Work Order ID 66529

Item Name: Alternate Wearplate Installation

DART SERVICE INSTRUCTION

TO AMEND INSTALLATION INSTRUCTIONS IIN-D412-742 REV. D
AND INSTRUCTIONS FOR CONTINUED AIRWORTHINESS ICA-D412-742 REV. 3

**FIGURE 1: CHANGE AT FORWARD SADDLE LOCATION
WITH DSI-9517-011 KIT INSTALLED**

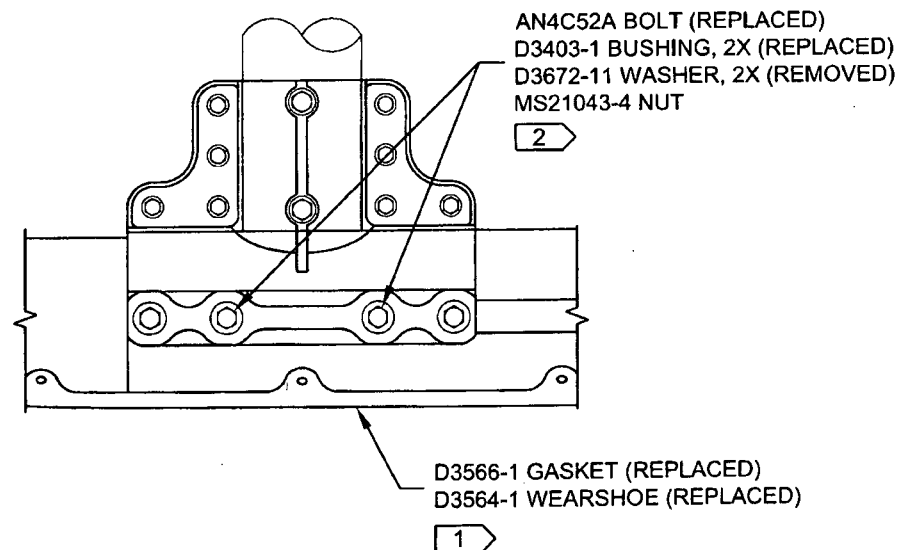
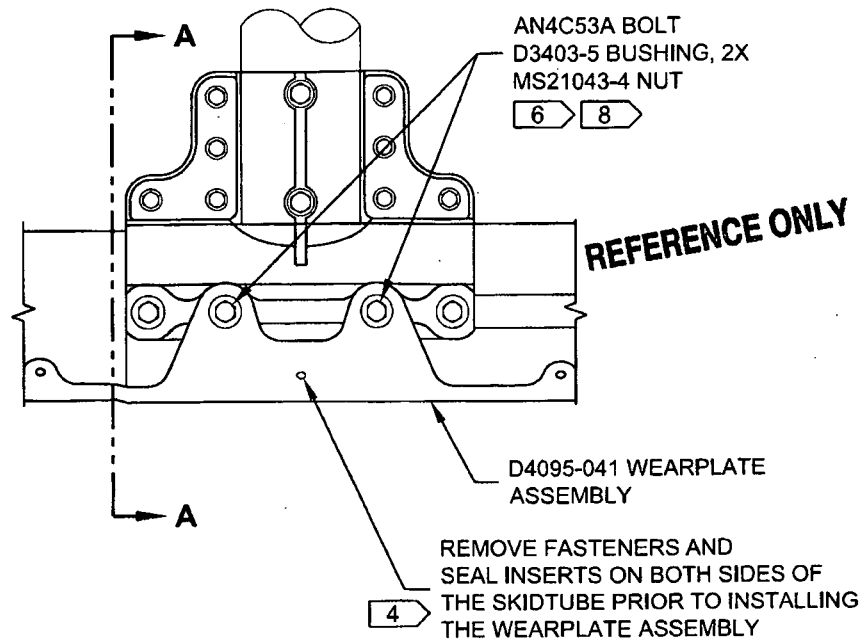
Mike and I are both in favour of upsizing the holes from Ø0.438 to Ø0.500 for ease of installation but you need to know about this change and we still need your OK.

Ian is preparing the DSI 9517 alternate wearplate kits by transfer drilling the holes from the mid tube to the wearplates and he is having slight alignment issues. This is mostly due to going Plus One Rockguard on the wearplates (neoprene gasket was being compressed against the saddle and now the harder material is not allowing for that). Ian has oversized the Ø0.438 transfer drilled holes to Ø0.500 to compensate on the first wearplate. Is it acceptable to upsize the hole on all of them?

Also, still about the wearplates with Plus One Rockguard, I believe that we may have to add the neoprene gasket anyway because removing the gasket creates a gap between the wearplates and saddles and upon torquing the nuts on the bolts, the two top hat bushings will meet resulting into a loose assembly. It might also make installer's life easier by upsizing the holes to Ø0.500.

As discussed, I'm not a big fan of the sloppy fit as I think this will allow the wearplate to rotate around the skidtube in service and create a similar problem to what we already had. So, I'm OK with the wearplate you've already made to 0.50", but I would leave the remaining holes at 0.44". If the customer struggles to get it on at 0.44", then we can allow him to open up to 0.50" in the field.
